# ZU1 SYSTEM BLOCK DIAGRAM

**PROJECT : ZU1**  
**Quanta Computer Inc.**

|   | <b>Block Diagram</b> | 3B  |
| Date: Tuesday, April 10, 2007 Sheet 1 of 39 |                      |     |

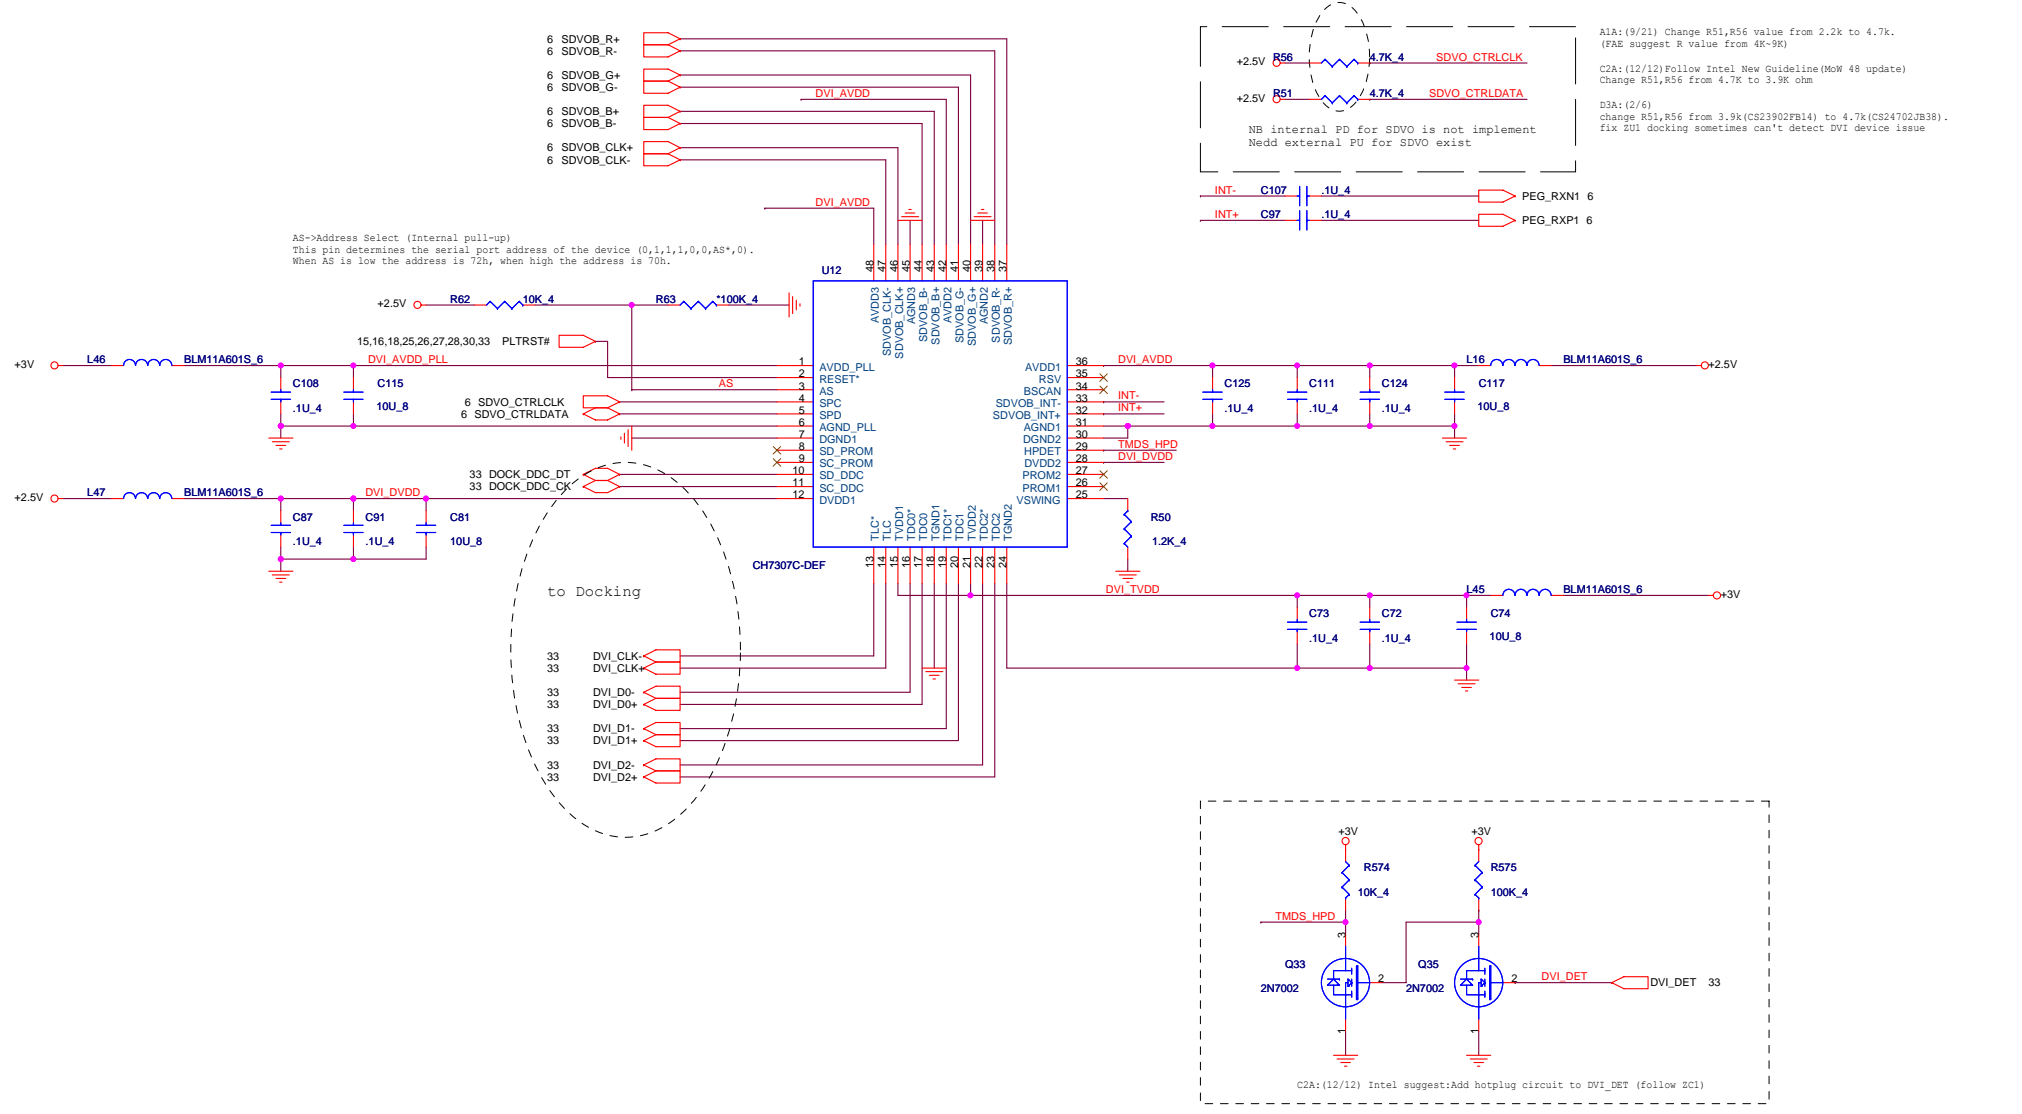
A1A: (9/21) Change R51,R56 value from 2.2k to 4.7k.  
 (FAE suggest R value from 4K-9K)  
 C2A: (12/12) Follow Intel New Guideline (MoW 48 update)  
 Change R51,R56 from 4.7k to 3.9k ohm  
 D3A: (2/6)  
 change R51,R56 from 3.9k(CS23902FB14) to 4.7k(CS24702JB38).  
 fix ZUI docking sometimes can't detect DVI device issue

C2A: (12/12) Intel suggest: Add hotplug circuit to DVI\_DET (follow ZC1)

D3A: (1/30) remove U13,R68,R75,R73,C98  
 1/16 confirm with CHRONTEL FAE,  
 he said we can remove CH9901 (U13),  
 If ZUI need support HDCP,  
 just need change controller from CH7307 to CH7313.  
 CH7313 already integrated HDCP function, no need external EEPROM.

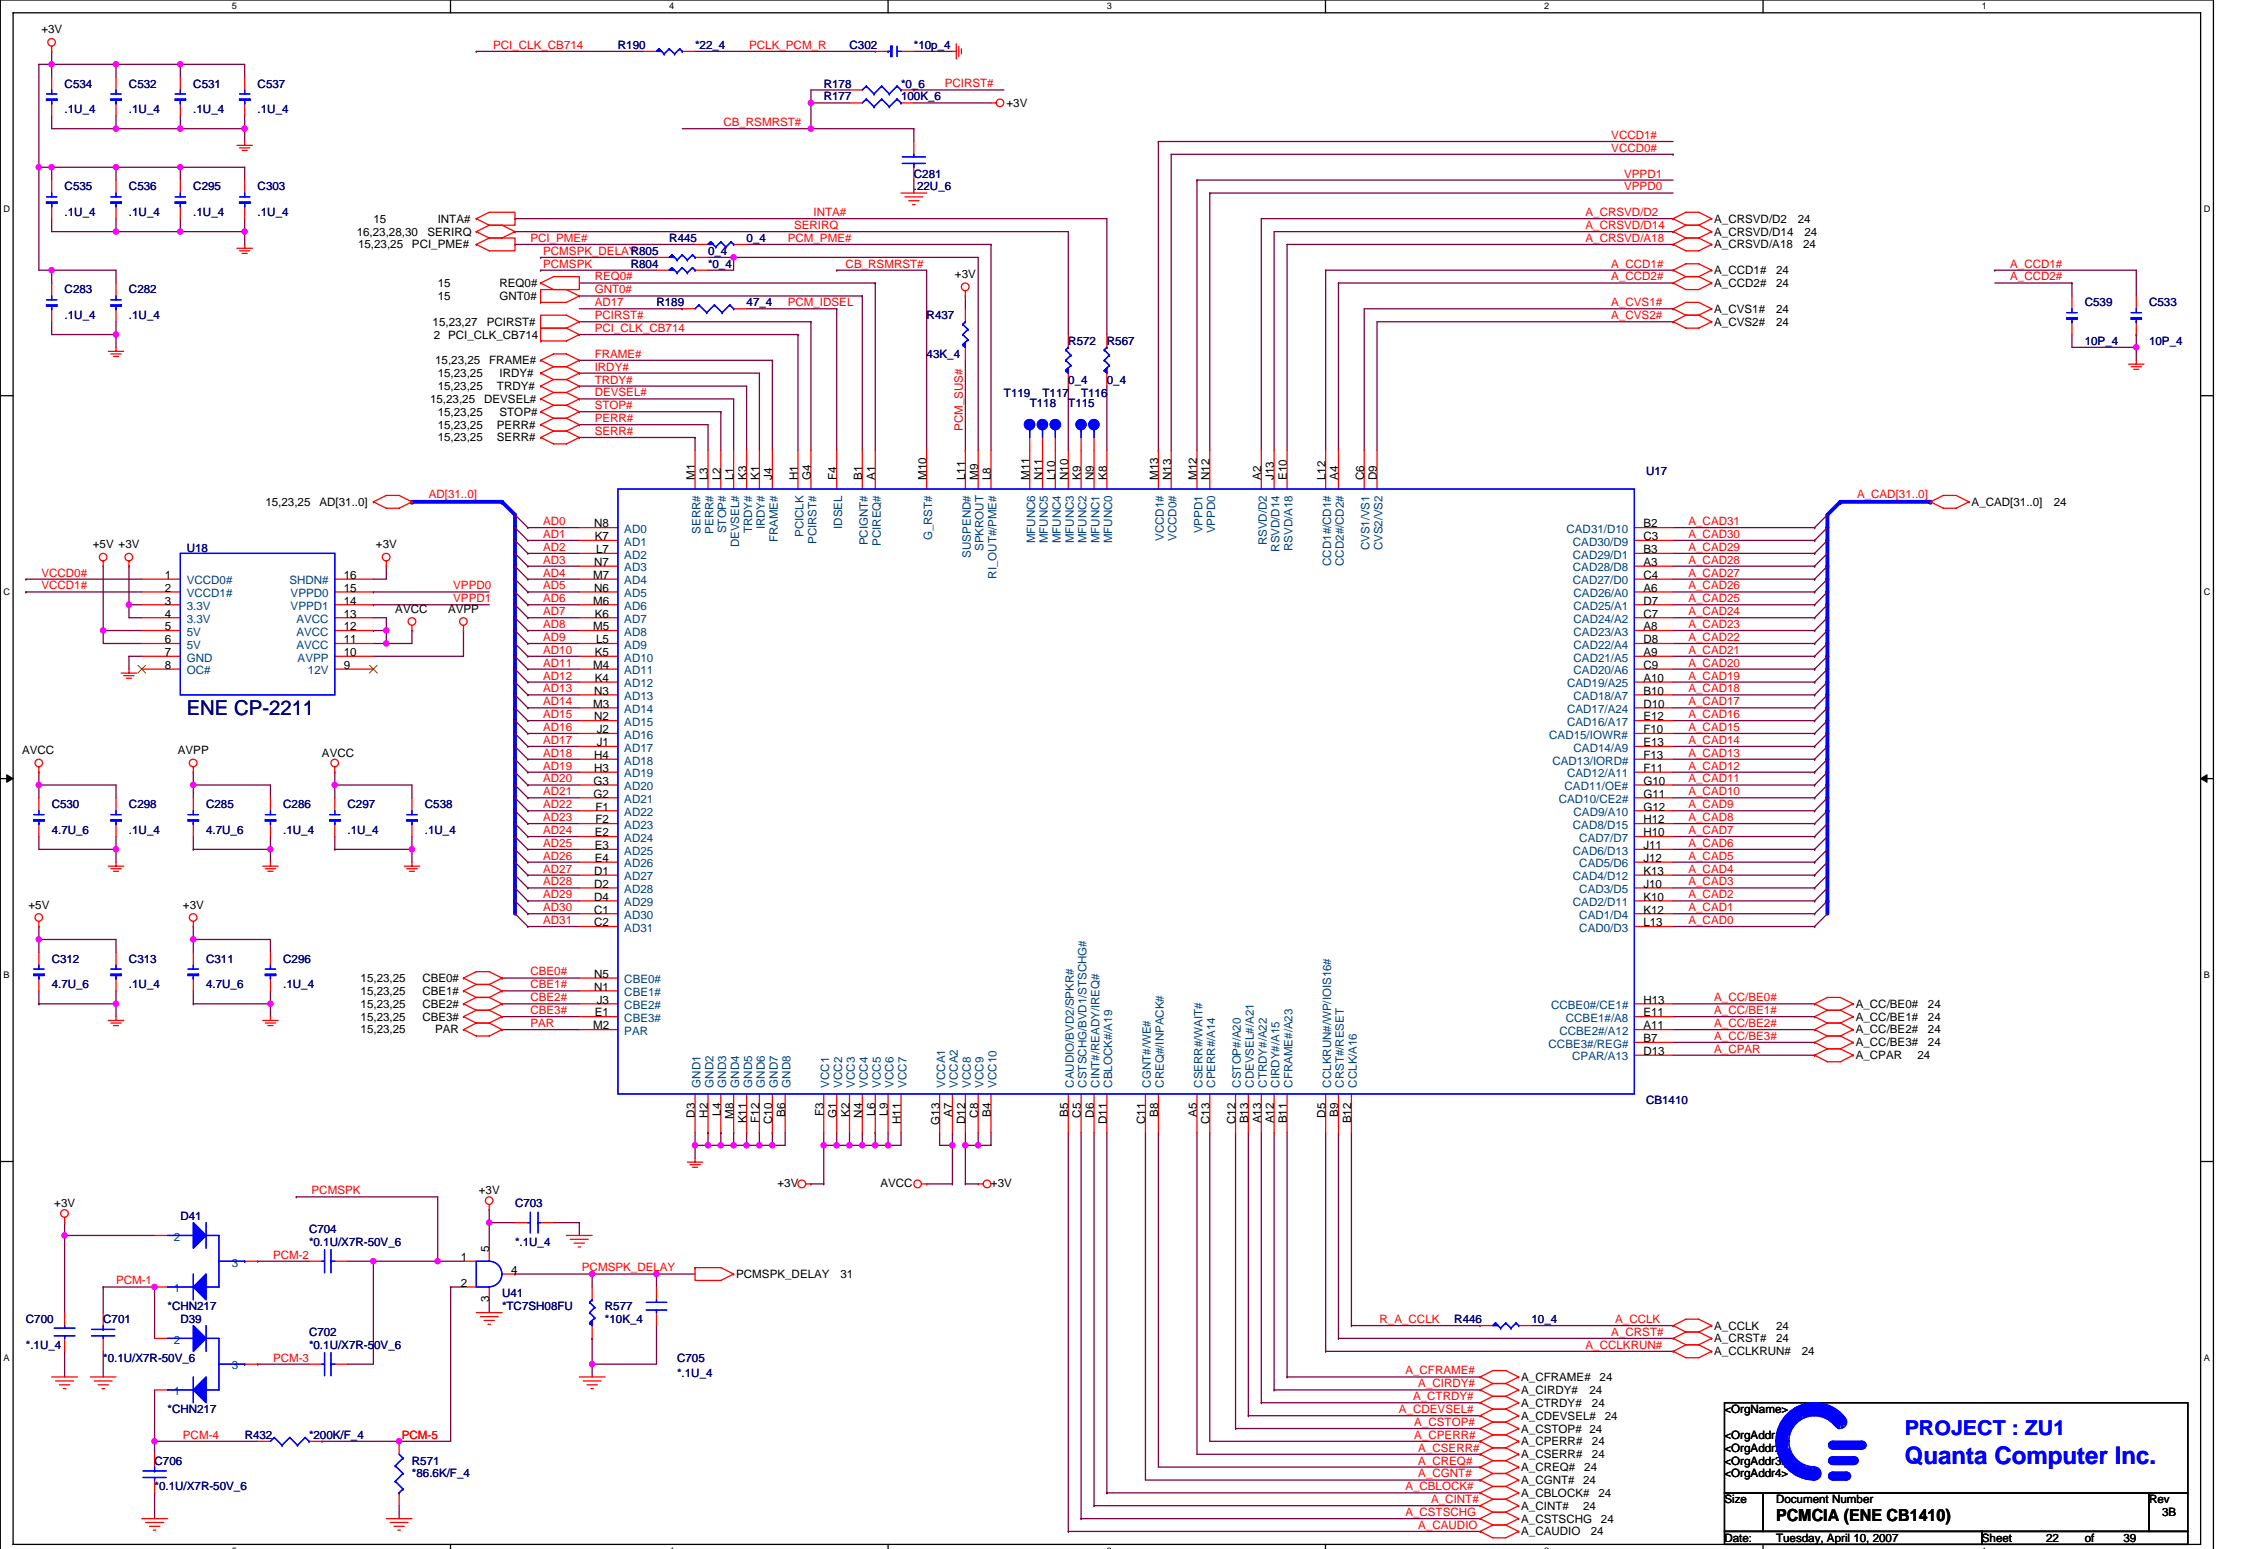
C2A: (12/22) confirm with FAE ->  
 Due to Intel VBIOS already integrate the EEPROM function.  
 ZUI will remove the U11,R57,R52,C109 to save layout space.

|       | <b>CARD Reader &amp; PCMCIA SLOT</b> | <b>3B</b>      |

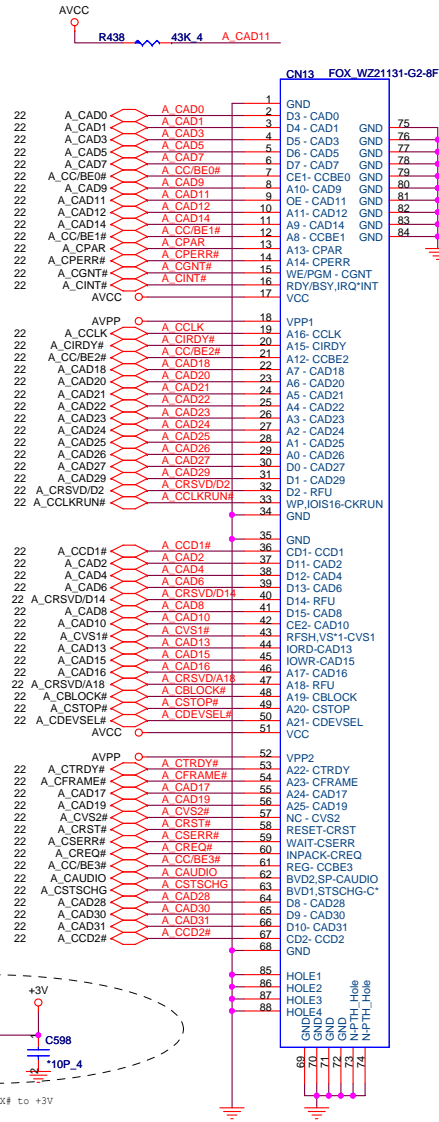
A1A:(9/26) For EMI solution (close to socket)

A1A:(9/22) Change PCMCIA CONN (follow BHI)

A1A:(9/26)Change C593 from 0.1u to 10uF  
 A1A:(9/28)EMI suggest add C587 0.1uF

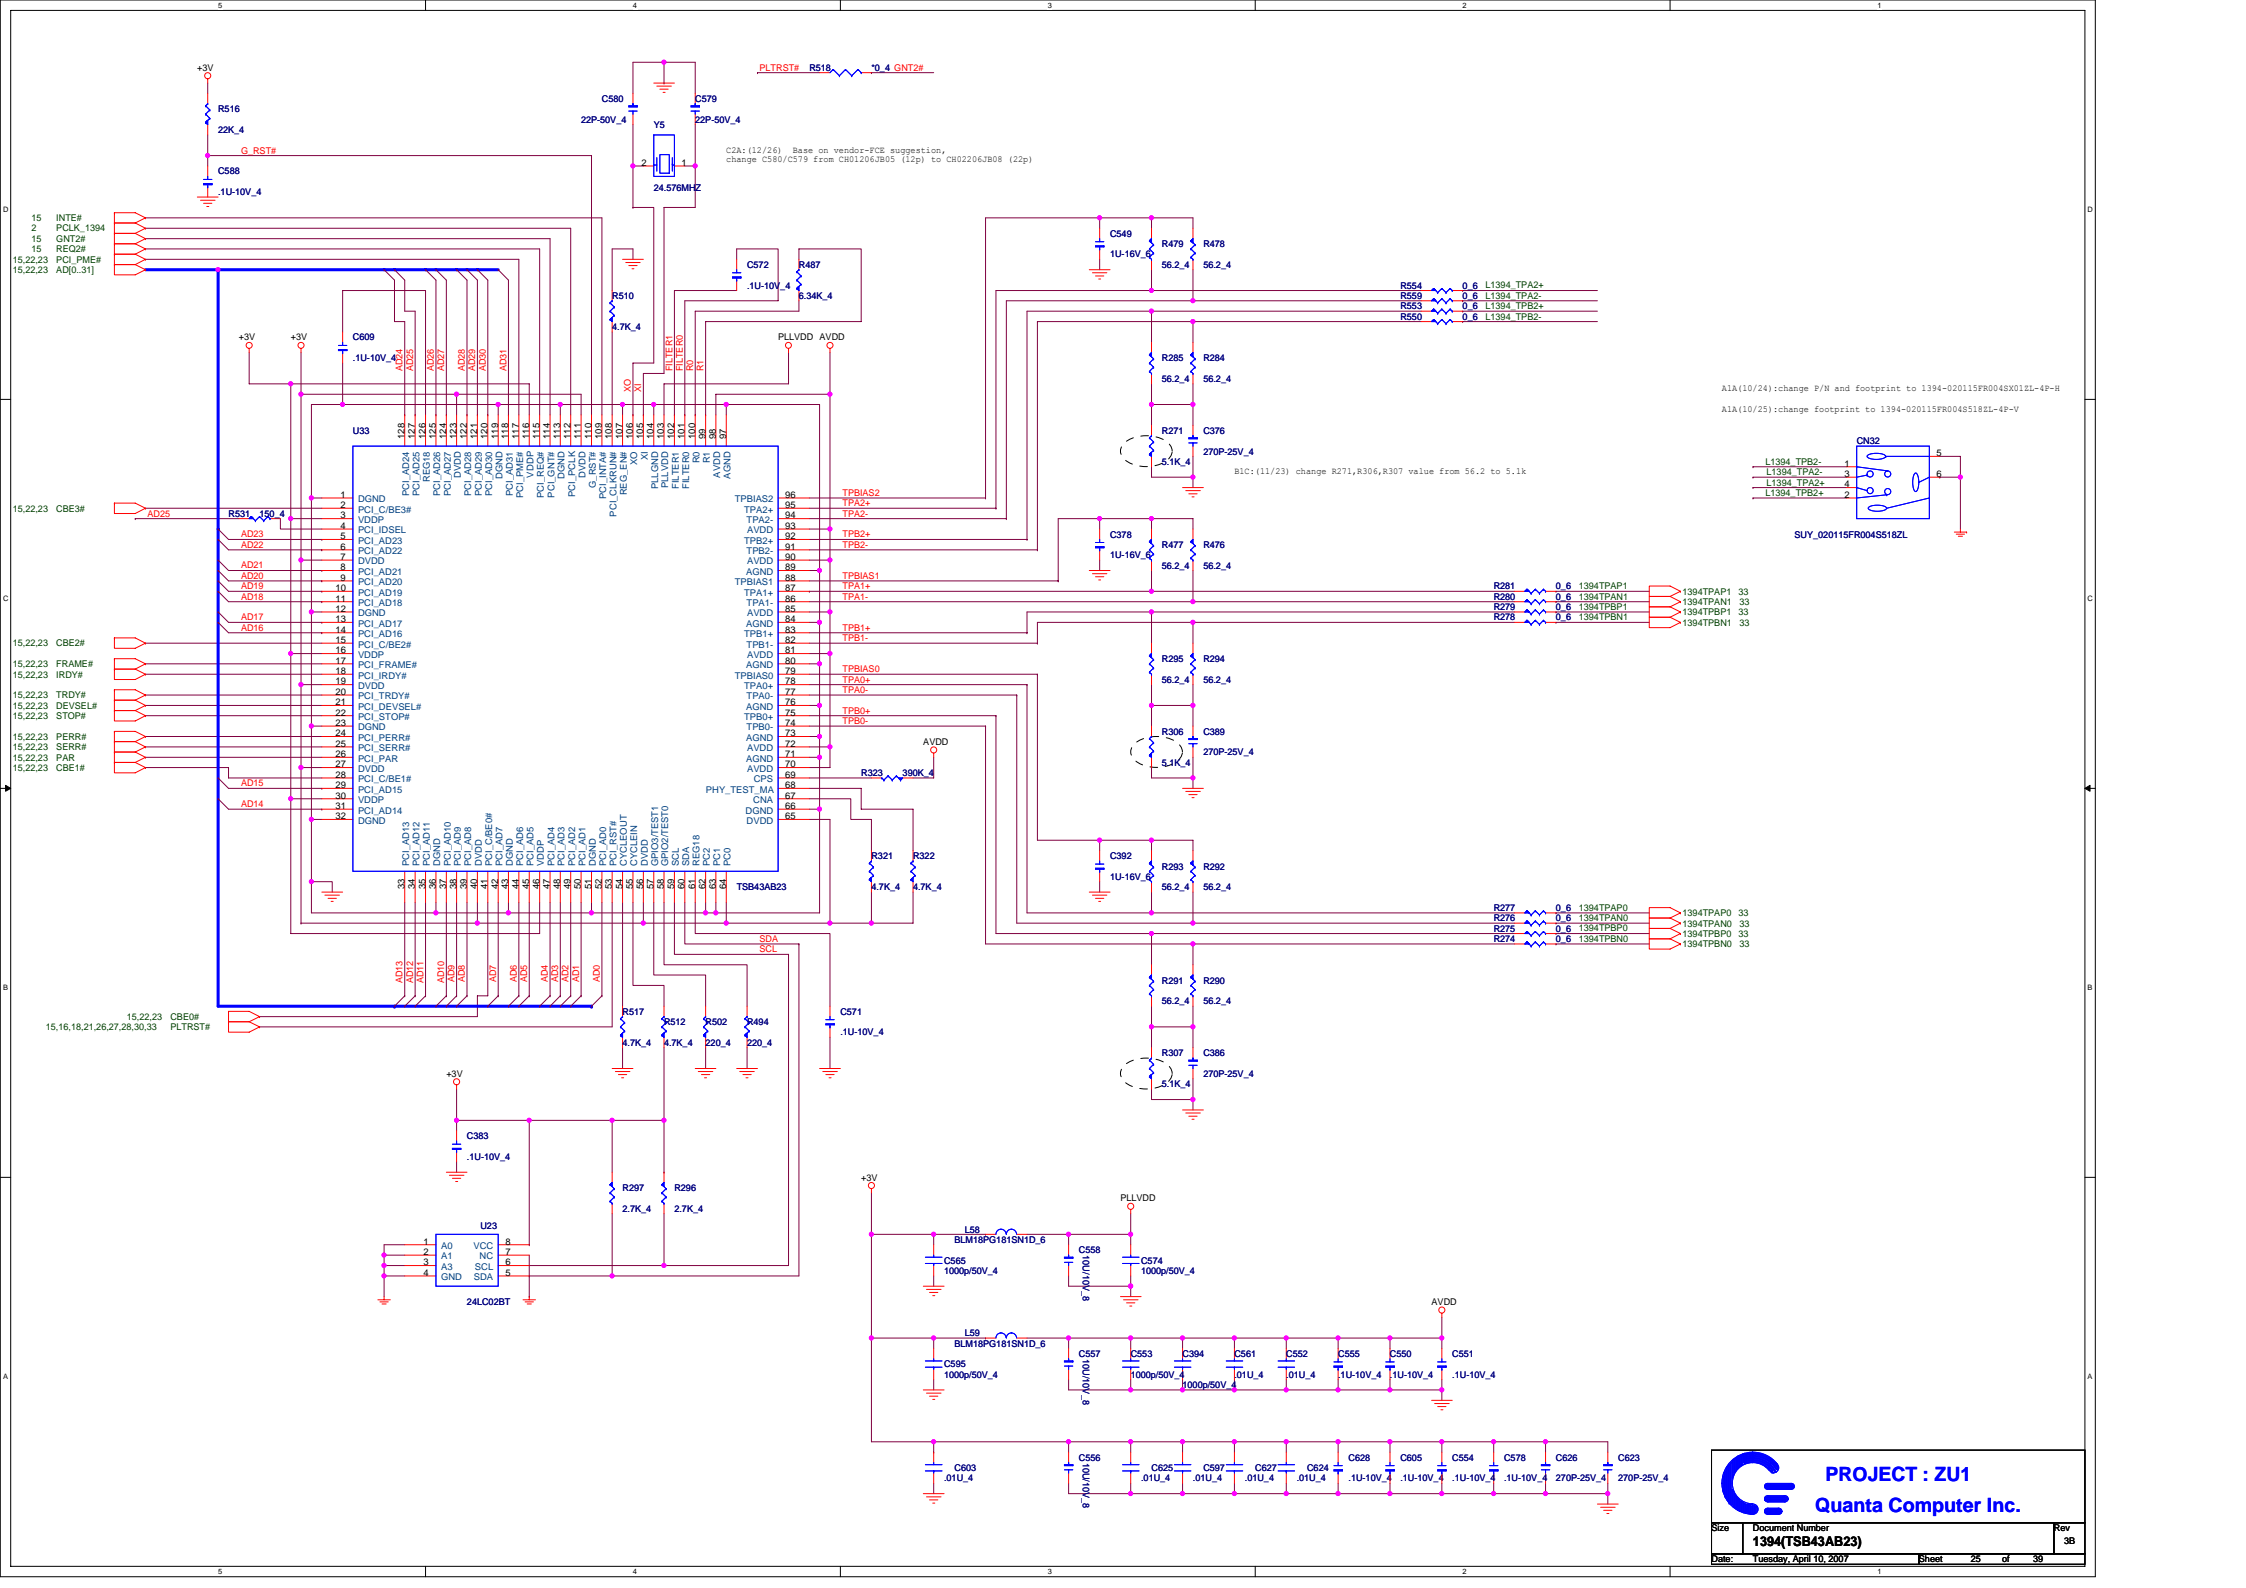
A1A(10/24):change P/N and footprint to 1394-020115FR0046X012L-4P-H  
 A1A(10/25):change footprint to 1394-020115FR0046S182L-4P-V

|       | <b>EC (PC8763LDG) FLASH</b> | <b>3B</b>      |

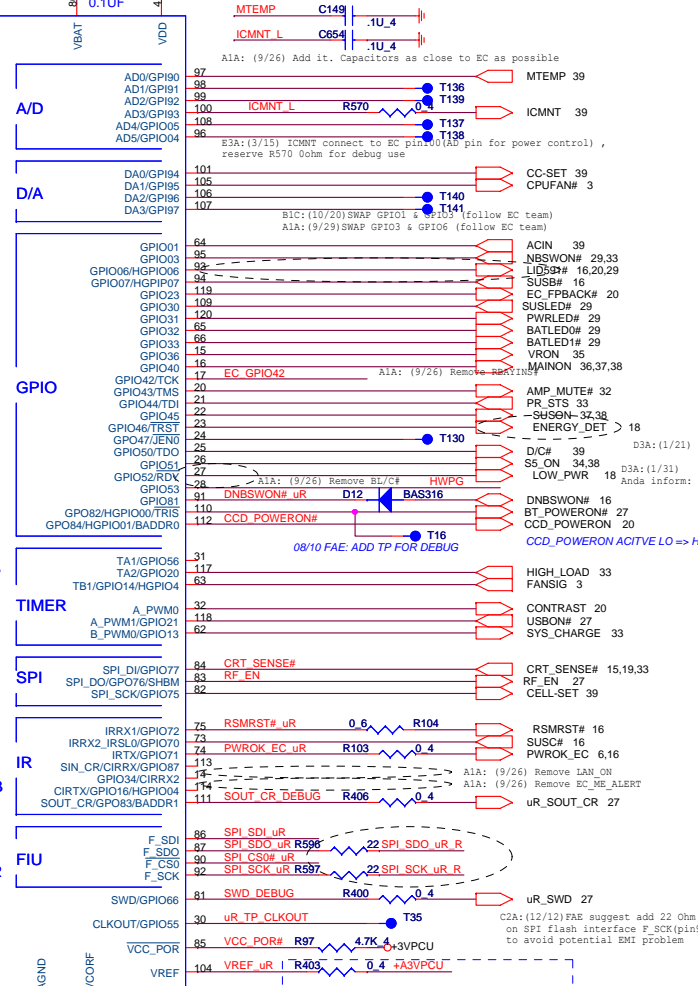
A1A: (9/16) Change from WPC8769 to WPC8763

08/10 FAE: SMI DOESN'T NEED DIODE

A1A: (9/27) change C130, C131 from 6.5p to 5.5p

C2A: (12/26) Base on vendor-FCE suggestion, change C130/C131 from CH-56067B01 (5.5p) to CH010063B01 (10p)

E3A: (3/16) PE request move D15-D18 location for FFC cable issue. Remove D16 footprint and net (HWPG\_3VPCU) to save layout space.

E3A: (3/15) ICNMT connect to EC pin 10 (AD pin for power control), reserve R570 0ohm for debug use

B1C: (10/20) SWAP GPIO1 & GPIO2 (follow EC team)

A1A: (9/29) SWAP GPIO3 & GPIO6 (follow EC team)

B1C: (11/28) change CN10/pin1 from +3V to +3VPCU

E3A: (3/22) confirm with BIOS-CM, no need LPC debug CONN, Remove CN6, R432 footprint to save space for layout.

**LED**

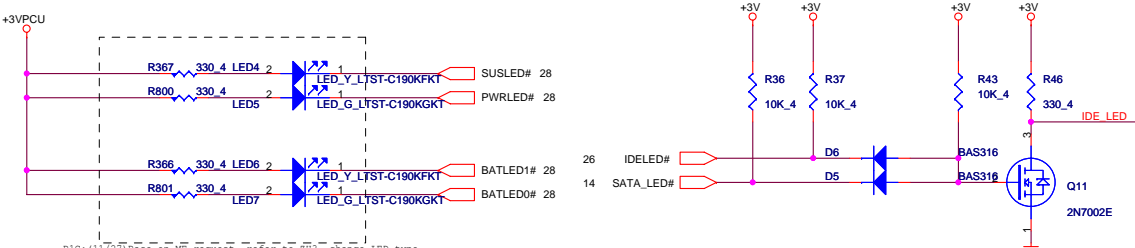
B1C: (11/27) Base on ME request, refer to ZH3, change LED type  
 B1C: (11/28) Base on ME request, change LED type  
 D3A: (1/24) Base on SMT-ME request, change LED type to 2 in 1  
 D3A: (3/16) Change LED2, LED3 type base on ME request, Add R800, R801  
 E3A: (3/30) ESD issue, change LED type (follow B stage)

A1A: (10/30) no stuff (ZUI no support EMAIL LED)  
 E3A: (3/30) Remove Q27, R1 footprint to save space for layout  
 ZUI no support E-Mail LED
